Clerk's Contract and Agreement Cover Page

Contract Description: Main Pumping Station - East Reservoir Addition

CONTRACT CHANGE ORDER NO. 1

OWNER: Village of Orland Park, Illinois
 CONTRACTOR: Joseph J. Henderson & Son, Inc.
 P.O. Box 9
 Gurnee, IL 60031
 CONTRACT: East Reservoir Addition

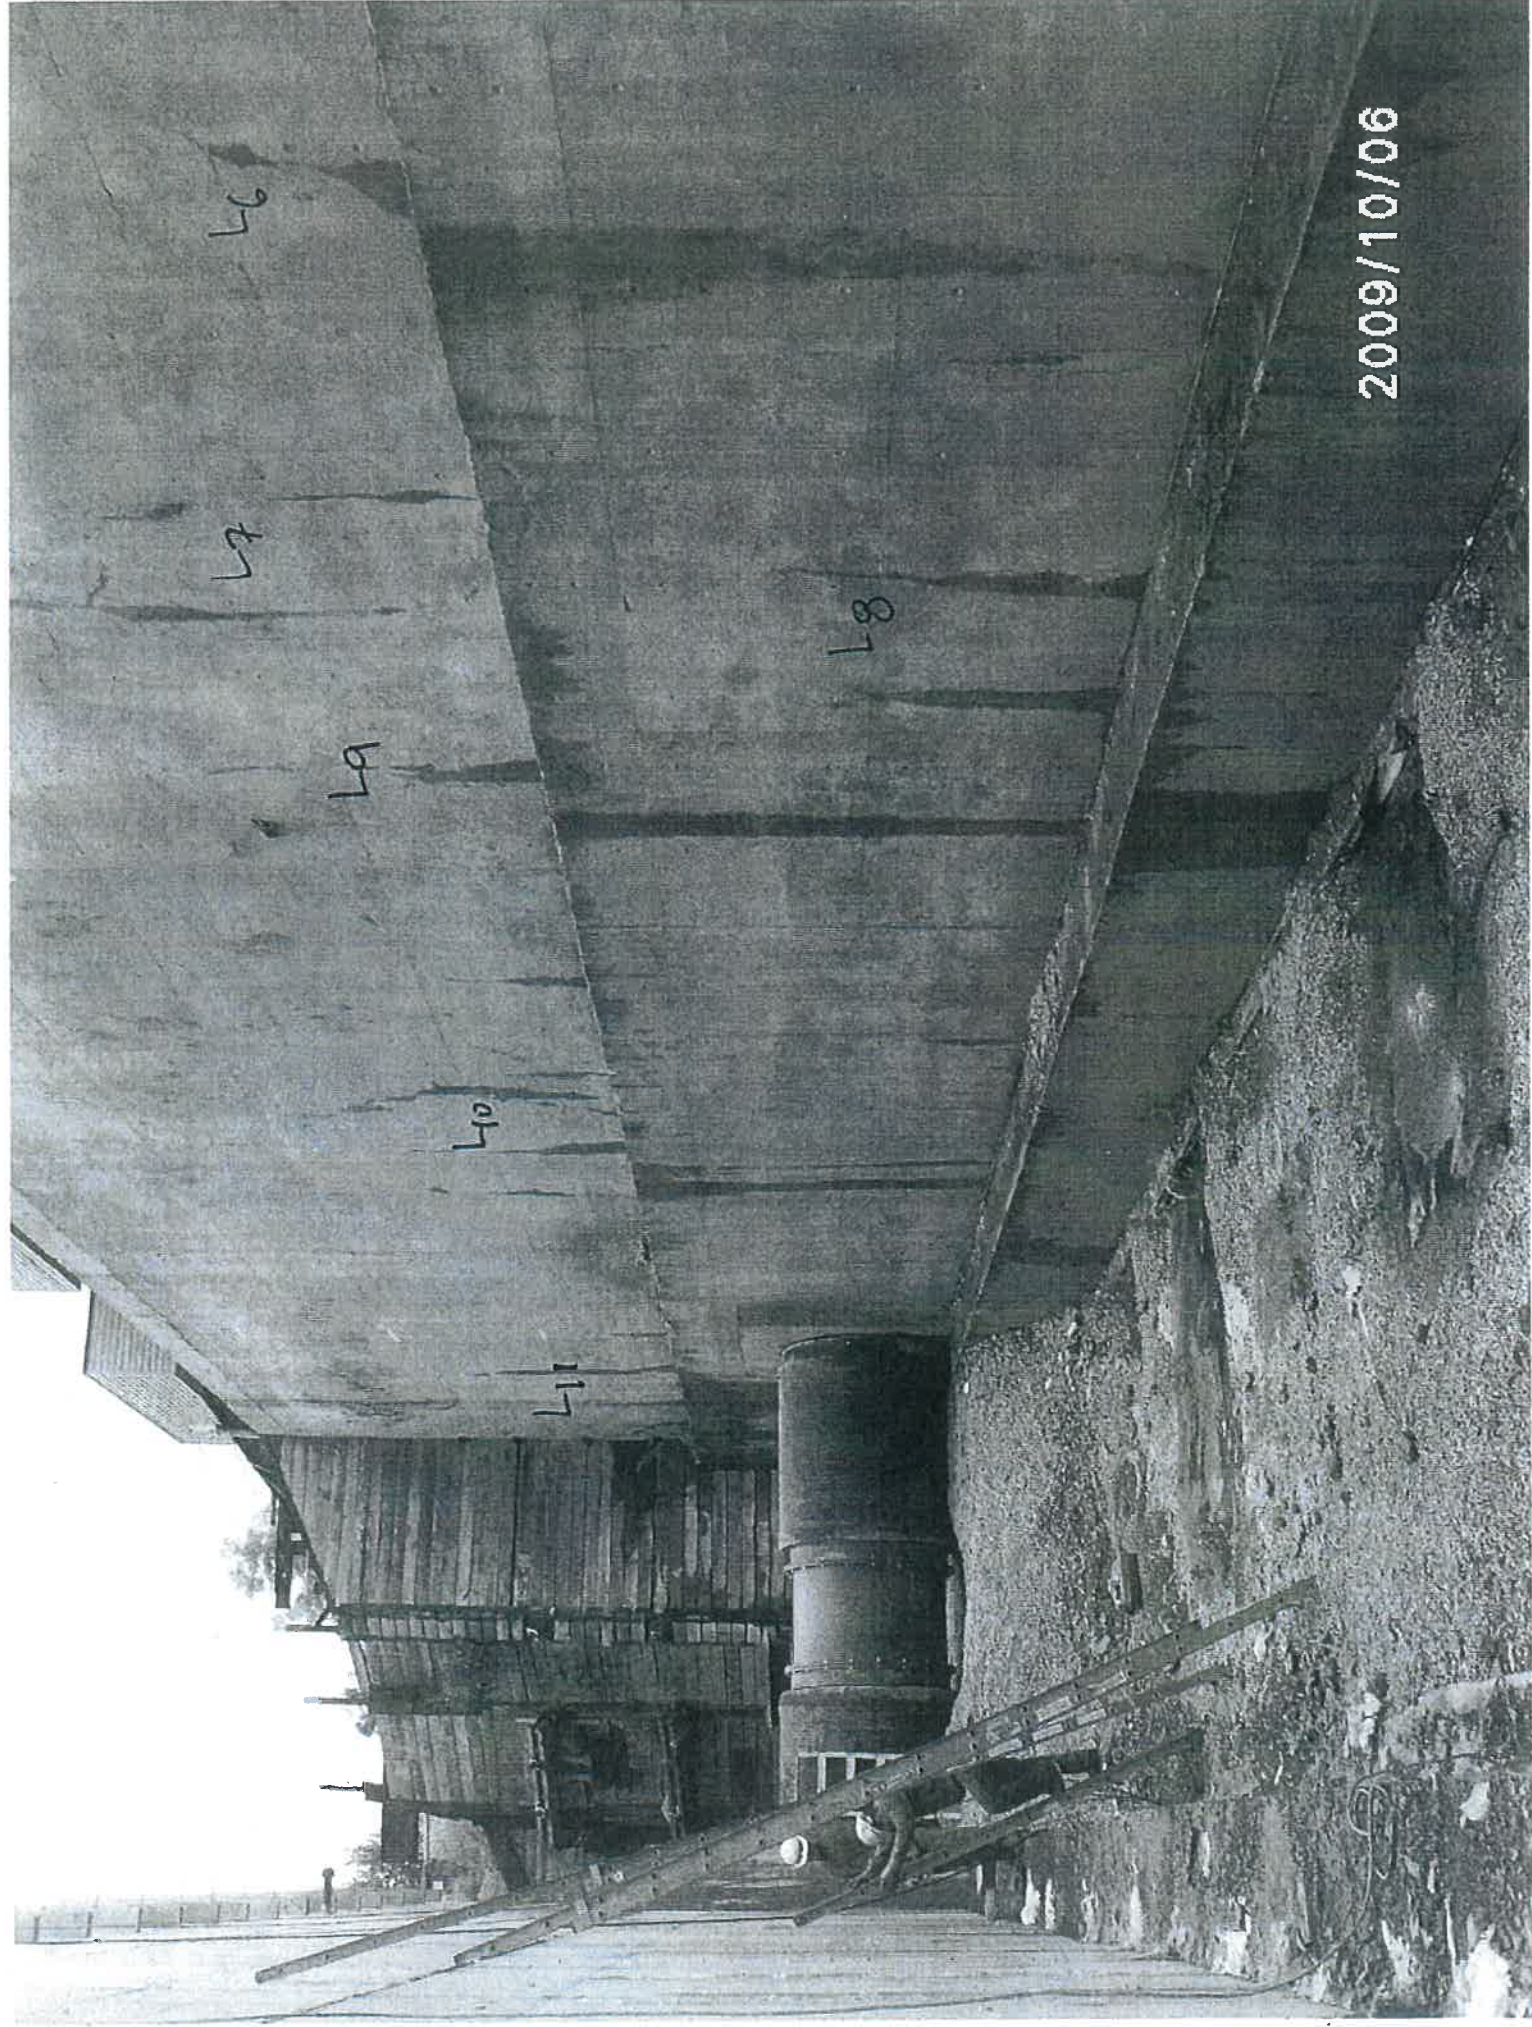
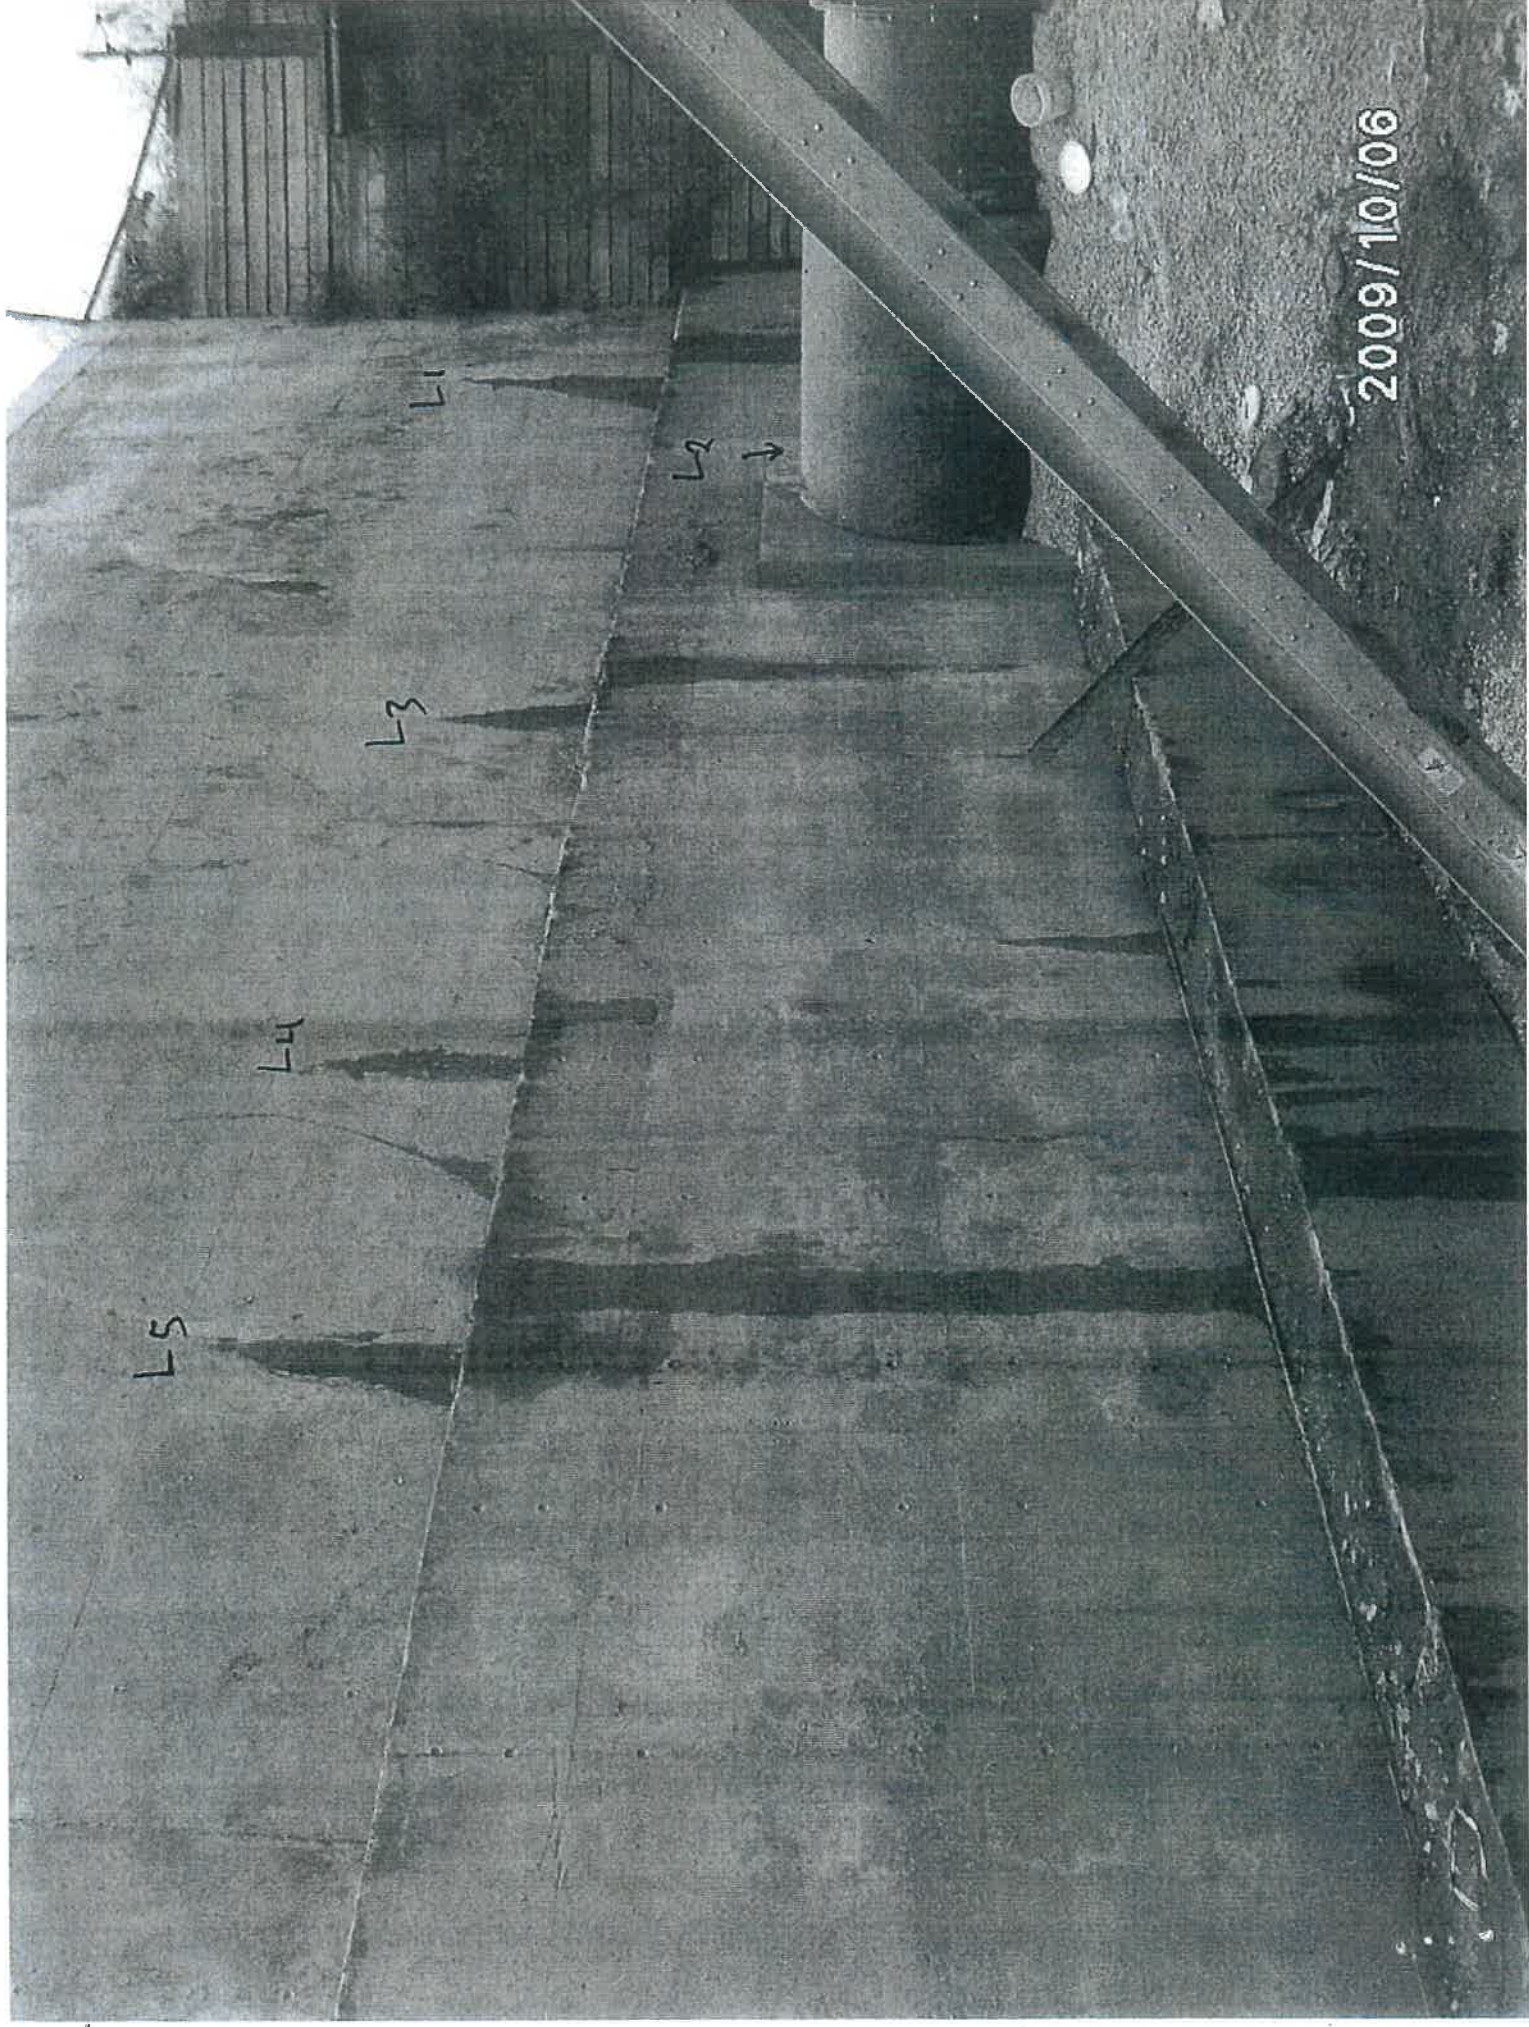
Keith has marked the visible leaks on the Central Reservoir wall. It appears that most of these are not very significant. I have attached the labeled photographs that Keith provided. Based on this information, we would like for JH to do the following:

- Monitor the cracks over the next few days with Keith while work continues on leak repairs for the East Reservoir
- Addition
- Provide a change order cost estimate for repair of cracks L5 and L10 for our consideration

Based on information gathered above, we can then determine if the Village should proceed with repair of cracks L5 and L10. Let me know if you have questions on this request.

SUPPLEMENTARY
DRAWING
SD02

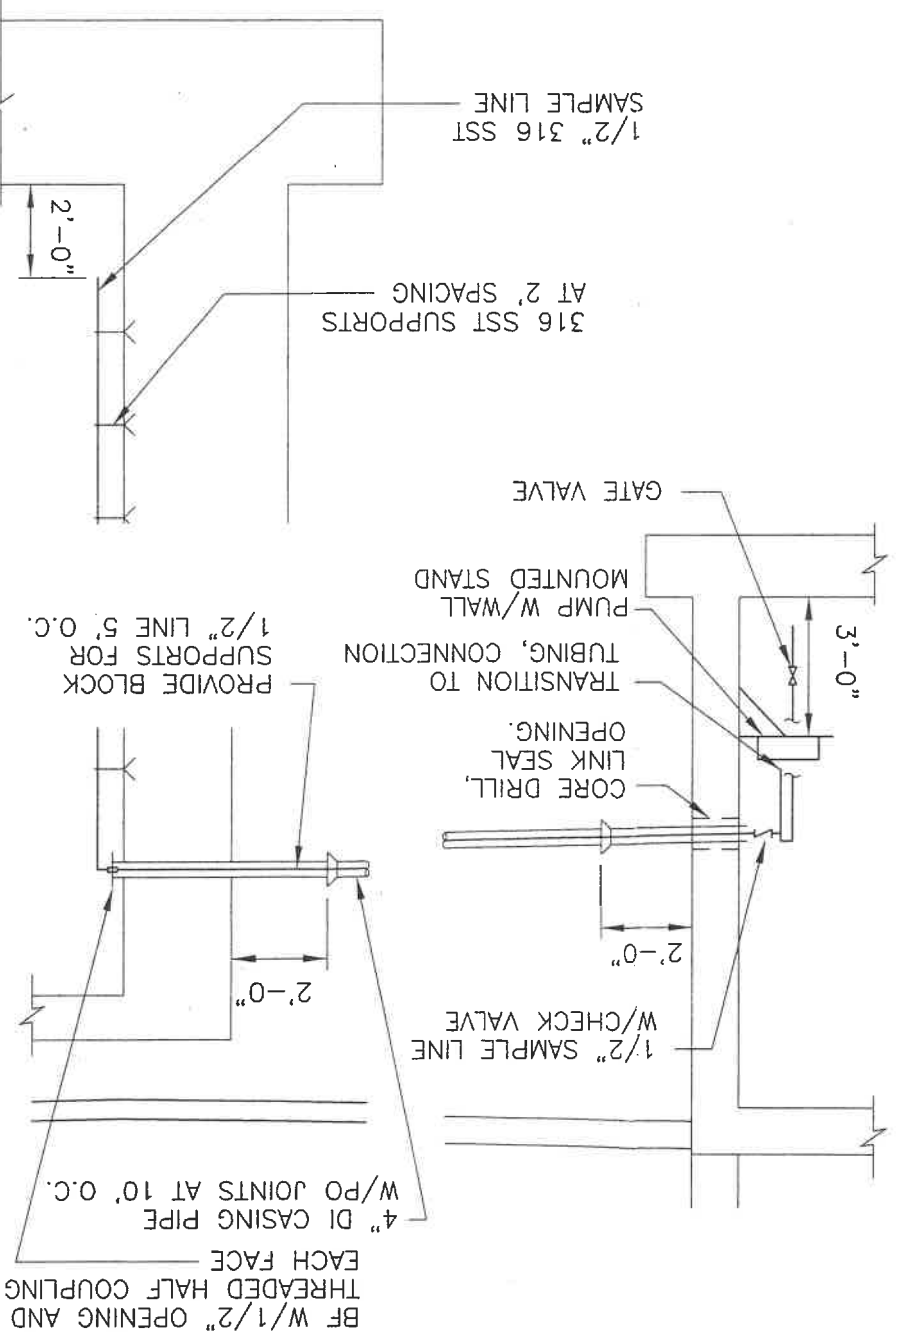
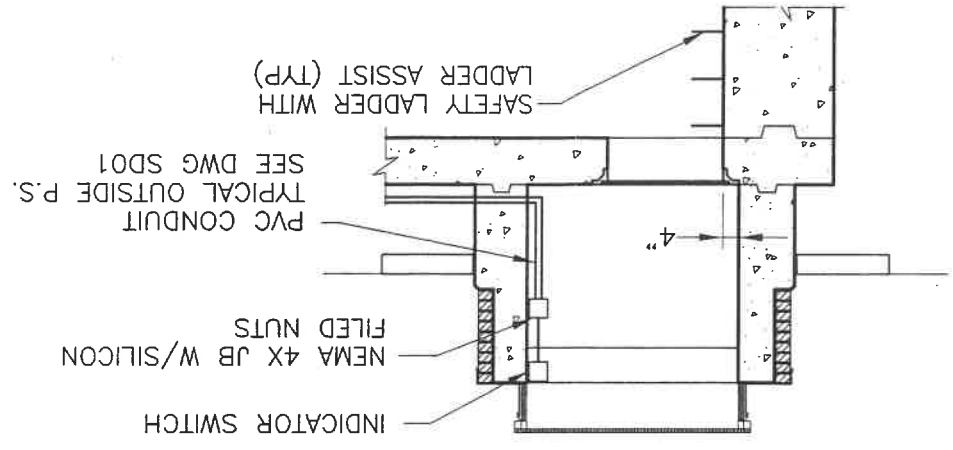
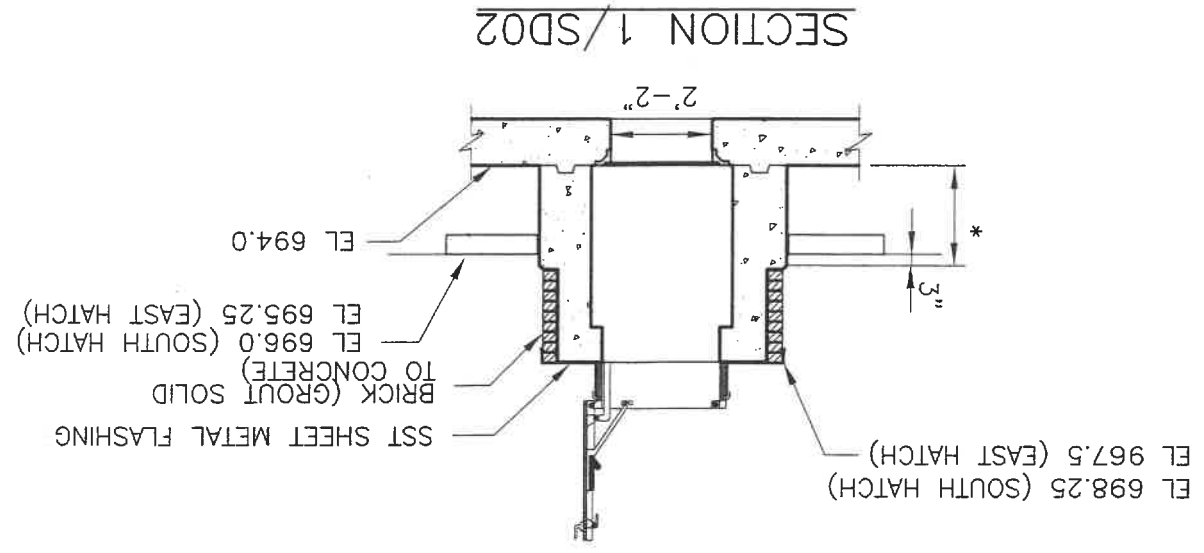
3. In order to obtain a permit to construct and operate, the Illinois Environmental Protection Agency required modifications to the project design including: addition of two access locations to the new East Reservoir Addition with above grade hatches and associated pump shelf, and associated electrical work. The two access hatches in the top slab replaced two of the three concrete slab openings, and were tied into the Main Pump Station Alarm System. The sampling pump was installed inside the Main Pump Station and sample line installed connecting the sampling pump to the new East Reservoir Addition to provide the Owner the ability to sample the water in the new East Reservoir. These modifications were added following acceptance of bids for the project. At the request of the Engineer and the Owner, JJH performed the requested work, which is documented in the Extra Work Order dated July 1, 2009. This work results in an increase in the Contract Price of\$51,944.87

Item No. 3 Joseph J. Henderson & Sons, Inc. Extra Work Order dated 07/01/2009
Supplemental Drawing SD01 "Reservoir Hatches" dated June 2009
Supplemental Drawing SD02 "Hatch Details" dated June 2009
Specification Section 04050 "Masonry Mortar and Grout"
Specification Section 04300 "Masonry"
Specification Section 07620 "Sheet Metal Flashing and Trim"
Specification Section 07724 "Access Hatches"
Specification Section 11318 "Sampling Pump"
Specification Section 15061 "Sampling Piping and Accessories"
Email from Beth Vogt dated 04/28/2009
